Access Compliance Report

Public Rights-of-Way

Intersection ID: 32121	Main Street: ALEXA_RD	Cross Street: PROVIDENCE_RD	Location: SW
ADA ID: 04D4114A96DB	Ramp Type: PerpDiag	Initial Pass/Fail: Fail	Overall Compliance: No
			Severity Score: 13.75

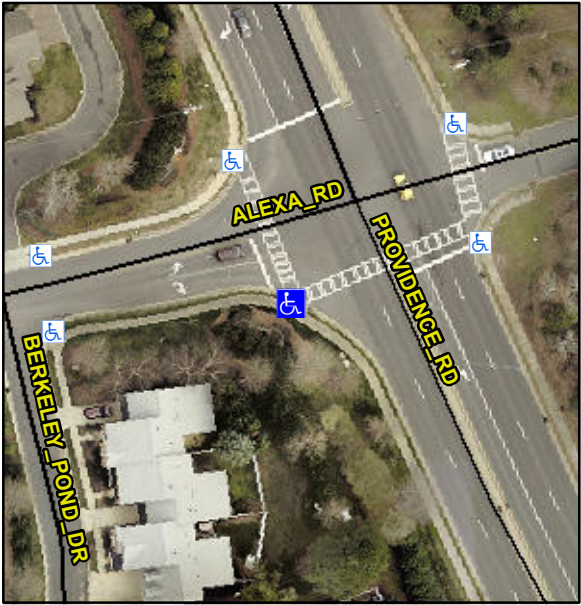
Compliance	Description	Data	Compliance	Description	Data
N/A	Ramp Length (in)	82.0	No	Ramp Slope (%)	8.7
Yes	Ramp Width (in)	48.0	Yes	Ramp XSlope (%)	3.9
N/A	Flare Type LT	N/A	N/A	Flare Type RT	N/A
N/A	Flare Slope LT (%)	N/A	N/A	Flare Slope RT (%)	N/A
N/A	Flare Traversable LT?	N/A	N/A	Flare Traversable RT?	N/A
N/A	Landing Length (in)	N/A	N/A	DWS Provided?	N/A
N/A	Landing Width (in)	N/A	N/A	DWS Contrast?	N/A
N/A	Landing Slope (%)	N/A	N/A	DWS Length (in)	N/A
N/A	Landing X Slope (%)	N/A	N/A	DWS Full Width?	N/A
N/A	Landing Curb? (Y/N)	N/A	N/A	DWS Offset (in)	N/A
N/A	Shared Landing?	N/A			
N/A	Gutter Ponding?	N/A	N/A	Gutter Slope (%)	N/A
N/A	Gutter Lip Ht (in)	N/A	N/A	Gutter X Slope (%)	N/A
N/A	Painted X Walk1?	Yes	N/A	Painted X Walk2?	Yes
	X Walk 1 Direction	To NE		X Walk 2 Direction	To NW
N/A	X Walk 1 Width (in)	76.0	N/A	X Walk 2 Width (in)	76.0
	X Walk 1 Slope (%)	1.6		X Walk 2 Slope (%)	3.0
	X Walk 1 X Slope (%)	3.8		X Walk 2 X Slope (%)	2.1

N/A	Ramp inside XWalk1?	Yes	N/A	Ramp inside XWalk2?	Yes
	Road Slope (%)	4.0	N/A	Clear Space?	N/A
	Road X Slope (%)	1.5	N/A	Clear Space to XWalk (in)	N/A
N/A	Any Obstructions?	N/A	N/A	Storm Grate/Utility Hazard?	N/A
	Obstruction Type			Storm Grate/Utility Type	
		N/A			N/A
		Yes		Surface Condition? (G/P)	Good

Codes/Mitigation Info/Possible Solution		Field Measurements/Component Compliance			
	Possible Solutions:				
	Remove & Replace Curb Ramp With Two New Directional Ramps or Equivalent.				
	Surveyor Notes:				
	N/A				
	PROW/ADA:				
	R304.2.2				
Street 1 Name	PROVIDENCE RD				
Stop Condition-Street 2	Signal				
Street 2 Name	ALEXA RD				
Stop Condition-Street 1	Signal				
Total Cost:		\$	3200.00
